# Access Compliance Report

## Public Rights-of-Way

Intersection ID: 43759	Main Street: DERVISH_LN	Cross Street: DUXFORD_LN	Location: NW
ADA ID: 75ABA84236B8	Ramp Type: BlendTrans1	Initial Pass/Fail: Fail	Overall Compliance: No
		Severity Score: 8.75

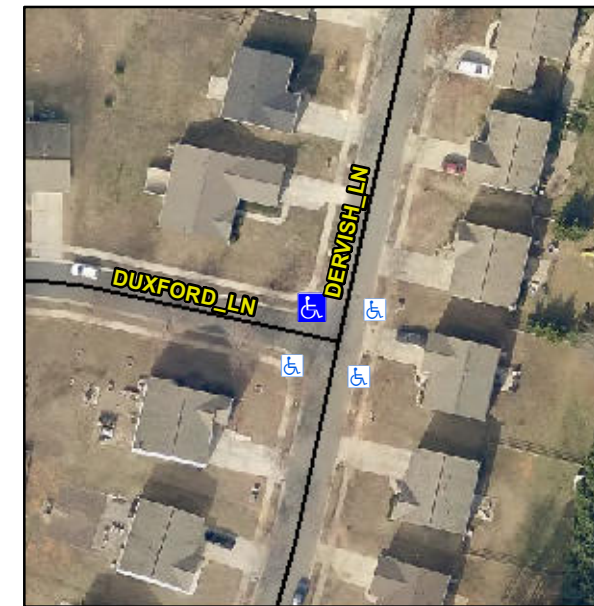
**Not Found, R304.5.1**

Compliance	Description	Data	Compliance	Description	Data
N/A	Ramp Length (in)	46.0	Yes	BlendTrans Slope (%)	2.7
No	Ramp Width (in)	46.5	Yes	BlendTrans XSlope (%)	0.5
N/A	Flare Type LT	N/A	N/A	Flare Type RT	N/A
N/A	Flare Slope LT (%)	N/A	N/A	Flare Slope RT (%)	N/A
N/A	Flare Traversable LT?	N/A	N/A	Flare Traversable RT?	N/A
N/A	Landing Length (in)	N/A	N/A	DWS Provided?	N/A
N/A	Landing Width (in)	N/A	N/A	DWS Contrast?	N/A
N/A	Landing Slope (%)	N/A	N/A	DWS Length (in)	N/A
N/A	Landing X Slope (%)	N/A	N/A	DWS Full Width?	N/A
N/A	Landing Curb? (Y/N)	N/A	N/A	DWS Offset (in)	N/A
N/A	Shared Landing?	N/A			
N/A	Gutter Ponding?	N/A	N/A	Gutter Slope (%)	N/A
N/A	Gutter Lip Ht (in)	N/A	N/A	Gutter X Slope (%)	N/A
N/A	Painted X Walk1?	No	N/A	Painted X Walk2?	No
	X Walk 1 Direction	To S		X Walk 2 Direction	To E
	X Walk 1 Width (in)	N/A		X Walk 2 Width (in)	N/A
	X Walk 1 Slope (%)	2.1		X Walk 2 Slope (%)	5.3
	X Walk 1 X Slope (%)	2.5		X Walk 2 X Slope (%)	0.1

N/A	Ramp inside XWalk1?	N/A	N/A	Ramp inside XWalk2?	N/A
	Road Slope (%)	0.7		Clear Space?	N/A
	Road X Slope (%)	4.5	N/A	Clear Space to XWalk (in)	N/A
N/A	Any Obstructions?	N/A	N/A	Storm Grate/Utility Hazard?	N/A
	Obstruction Type			Storm Grate/Utility Type	
		N/A			N/A
			Yes	Surface Condition? (G/P)	Good
			No	Curb Slope (%)	12.9

**Remove & Replace Curb Ramp With Two New Directional Ramps or Equivalent.**
